PLANNING PROPOSAL CASTLE HILL NORTH PRECINCT

Thank you for your letter regarding the above planning proposal. This is the combined response of Transport for NSW and Roads and Maritime Services, collectively TfNSW.

Attachment A

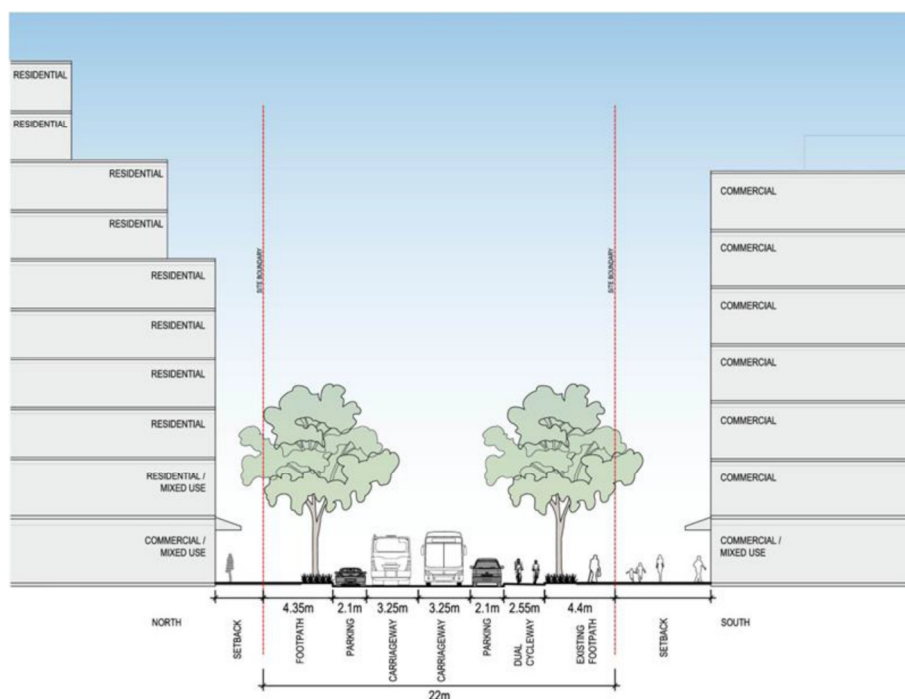
The proposed strip acquisition to achieve a widening of Castle Street and Old Castle Hill Road is supported. The proposed allocation of the widened road space (see diagram below) is requested to be re-allocated so as to achieve one lane 3.5m wide to support efficient movement of bus services as recommended in documents including *Austroads Guidelines* and *State Transit Infrastructure Guide*. It is unlikely that a bus stop can be provided on a parking lane that is 2.1 metres wide without obstructing traffic flow in the adjoining carriageway and this may also require re-allocation of the parking lane to at least 2.5 to 3.0 metres to meet the recommended lane width in *State Transit Infrastructure Guide*.

Northern and Southern Pedestrian Bridges

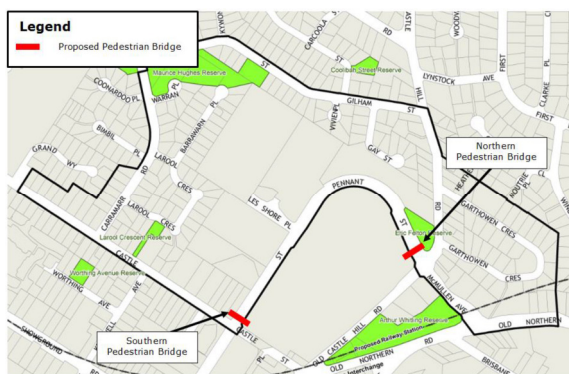
The Southern and Northern Pedestrian bridges over Pennant Street are supported in principle. These bridges will need to be designed and constructed in accordance with relevant Roads and Maritime Pedestrian Bridge Design Standards, ensure that there is a minimum clearance of 5.5m from the road pavement to the underside of the structure, preferably be designed to provide ramps for the mobility impaired (if / where sufficient land is available), ensure that they do not obstruct vision to nearby traffic signals, be integrated into adjoining developments and ensure that the bridge support structures are located sufficiently clear of any proposed future road reserve requirements which would be identified as part of the TMAP.
